Well #709

CONTRACT NO 81-C-1644	TRANSMITTAL NO 182	DATE 3-18-86
---------------------------------	------------------------------	------------------------

PROJECT TITLE AND LOCATION
Holcomb Blvd Water Treatment Plant

MGB, Cp Lejeune, North Carolina

WELL # 11.

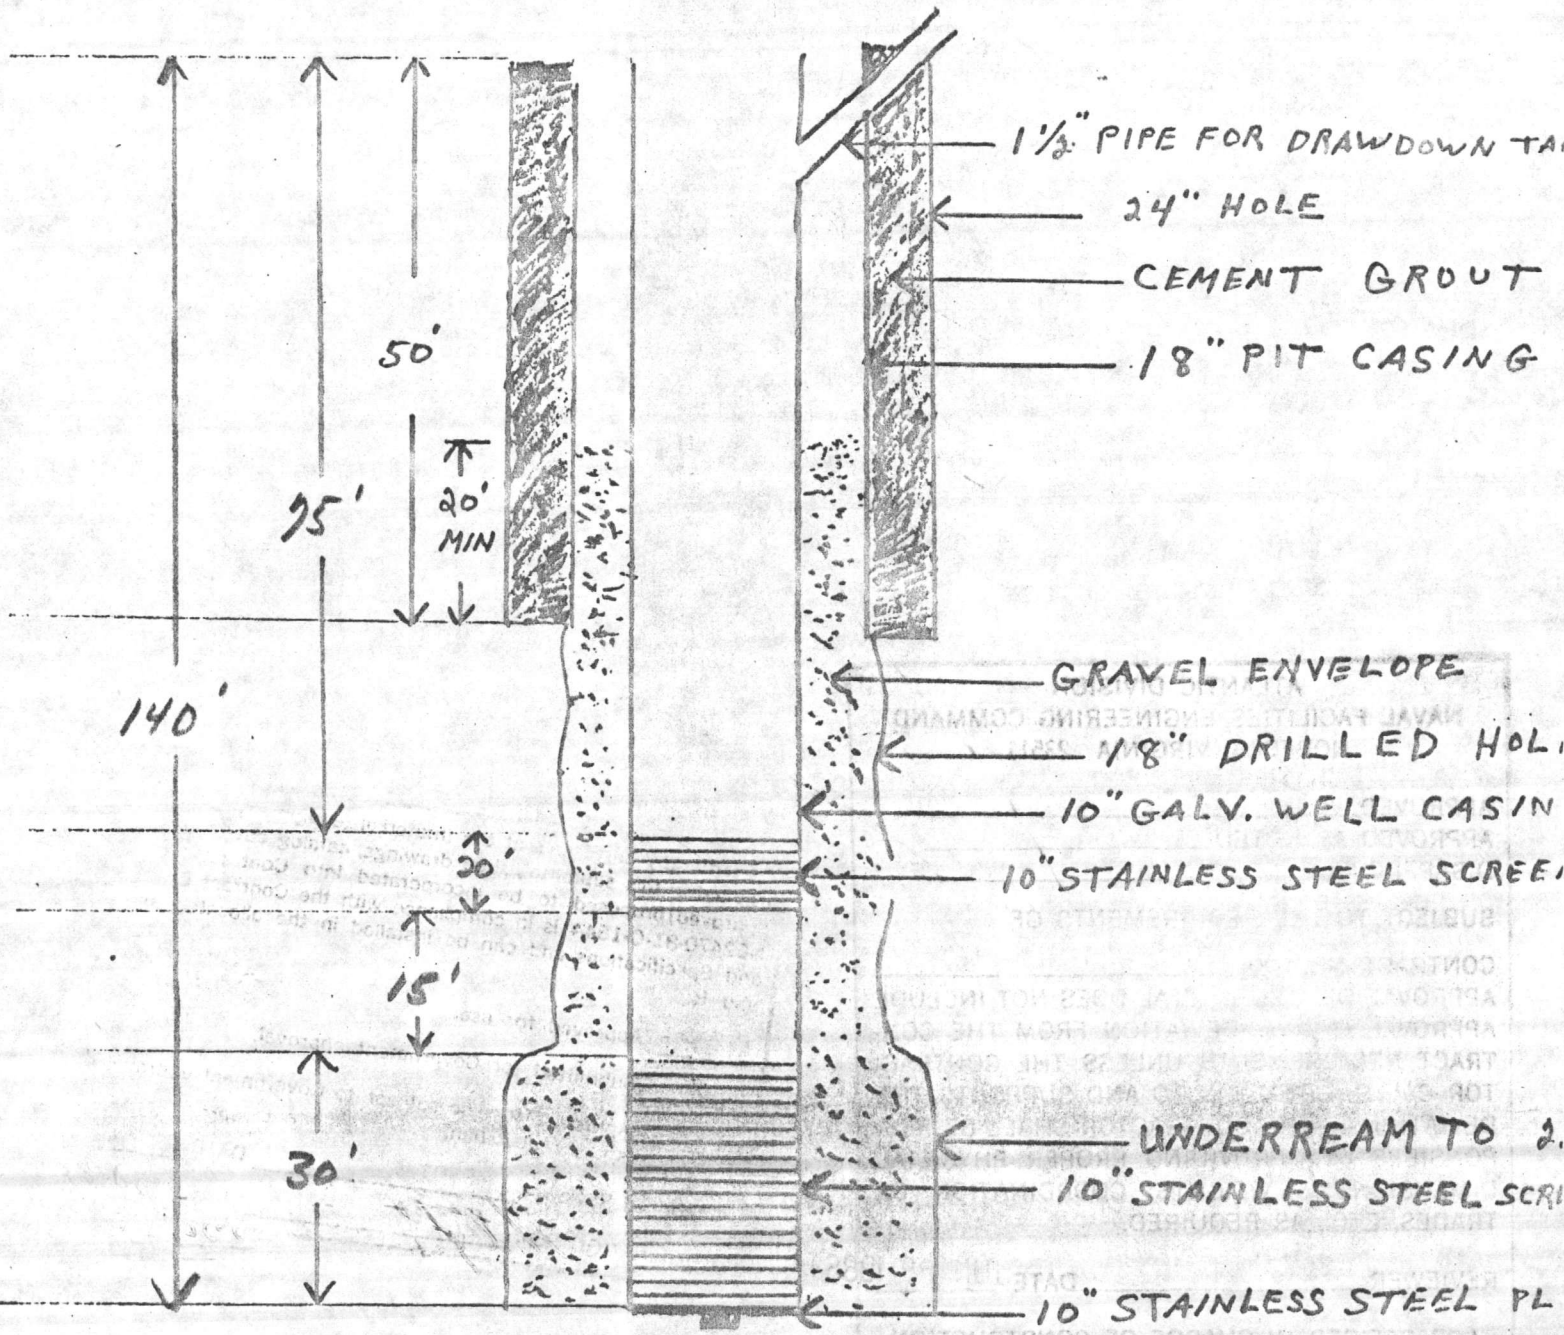
An Additional ten (10) feet of screen was added.

This Shop Drawing replaces Shop Drawing previously submitted. See Transmittal # 150 dated 1-16-86.
